Environmental Services - Water Quality
Onsite Wastewater Scan Data Entry Form

PERMIT #: 8028394

WAKE COUNTY HEALTH DEPARTMENT SEPTIC TANK LAYOUT AND PERMIT

1/3/09 SURVEY FOR
DOROTHY G. RICE

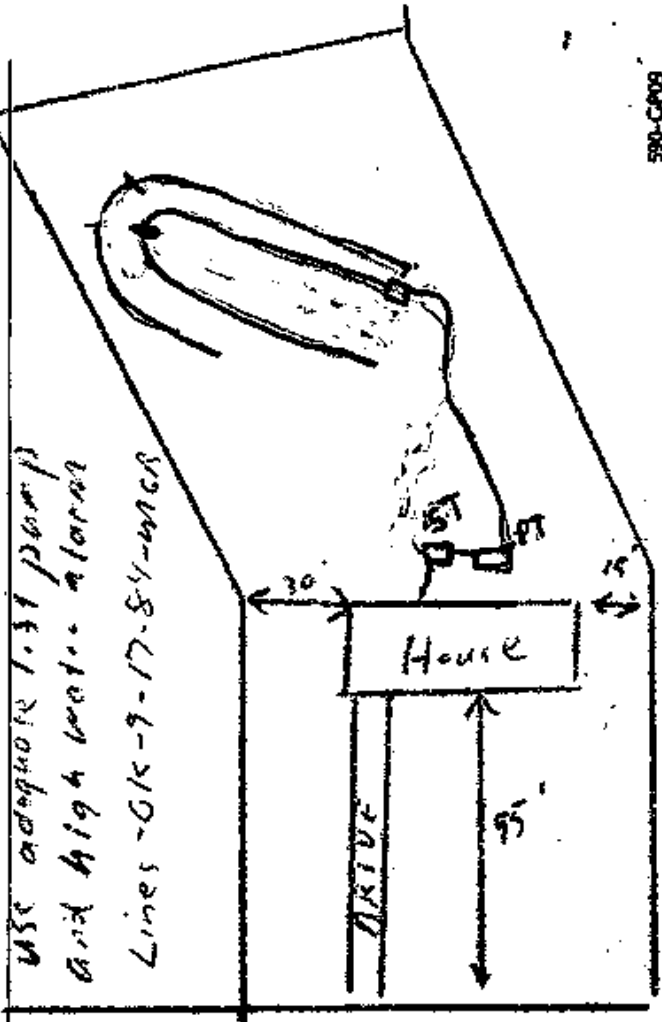
Use adequate 1.5 ft pump
and high water alarm
Lines - 6K-9-17-84-wcc

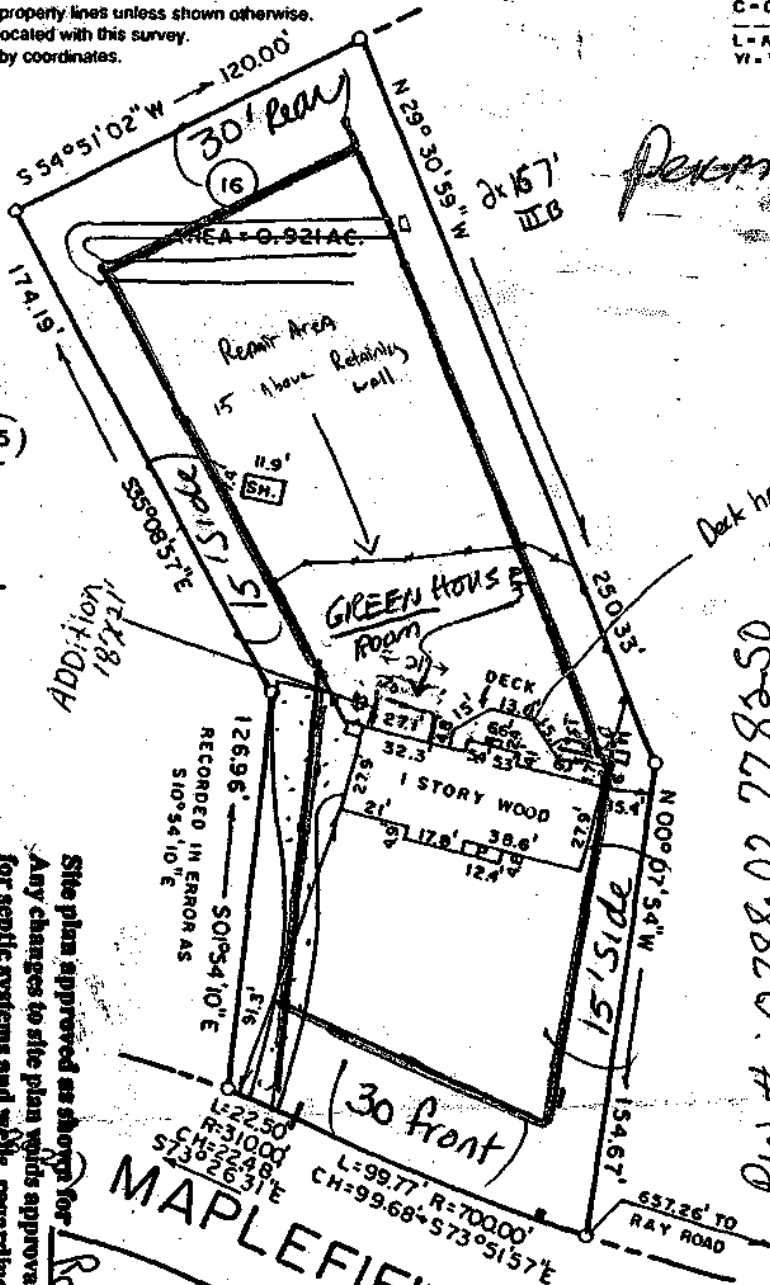
Site plan approved as shown for Room Addition.
Any changes to site plan require approval. All setbacks apply for septic systems and wells, regarding any pools, decks, additions and/or accessory structures. Applicant is responsible for protecting all portions of the septic system, retaining walls from damage during construction. Adhere to all State Rules.
Approved by [Signature]
Wake County Department of Environmental Services
Water and Waste Water Section

Deck has been removed
will revise + apply for
deck on later date
6-18-09 Only want room/greenhouse
Approved
